Permission Decision Support Document

Decision Maker	Mark Davies (Operations Director, Western South Island Region)
Applicant	Griffin Creek Hydro Limited (The Applicant)
Permission Number	WC-20844-OTH
Permission Type	Variation/s - (s17ZC(2) material change and s17ZC(1) minor and technical)

Figure 1 – Aerial and topo maps from the Application showing the location of the original penstock/pipeline with separate access route (bright red and blue lines in aerial image) and proposed amended penstock route (penstock and access combined).

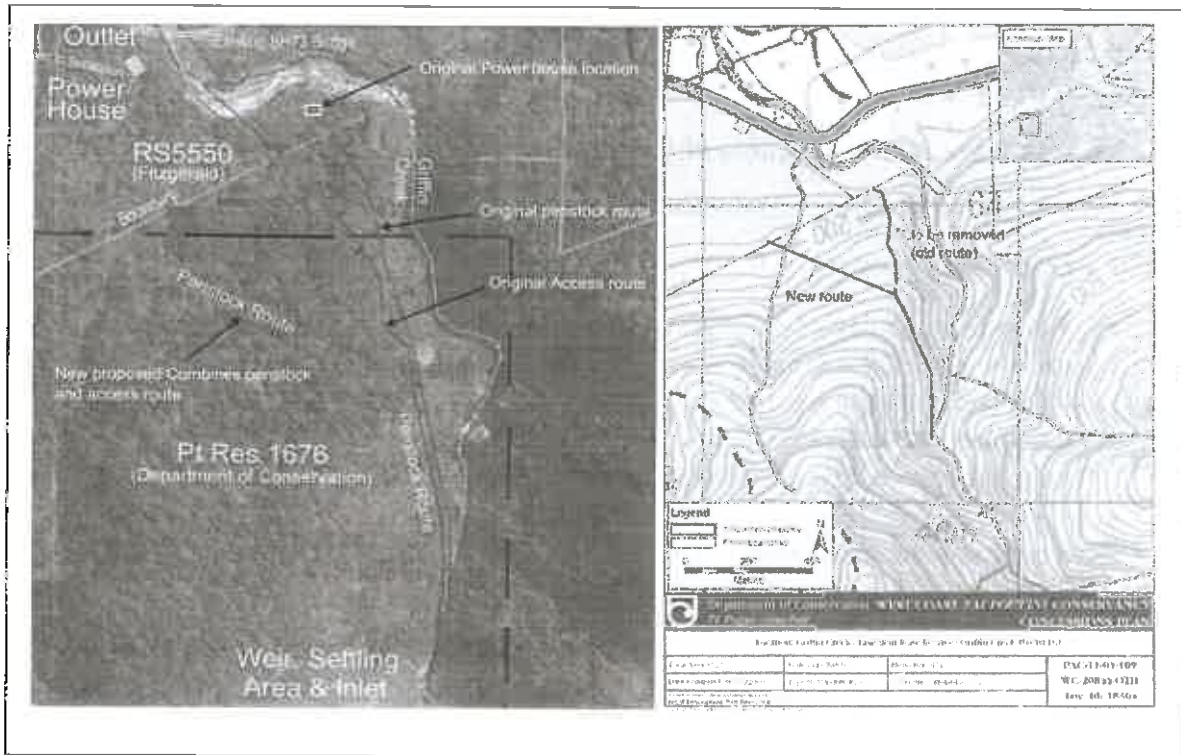
- Amendment of part of the easement area location due to relocation of the penstock and removal of the access track as shown in Figure 1 below. The penstock pipe would be buried and sidle across the hill (before the steep penstock section on private adjoining land). A separate access track for maintenance purposes would no longer be required as the penstock/pipeline would be buried within the same corridor.

Figure one below from the Application shows the original scheme design layout compared to the proposed amended scheme design layout.
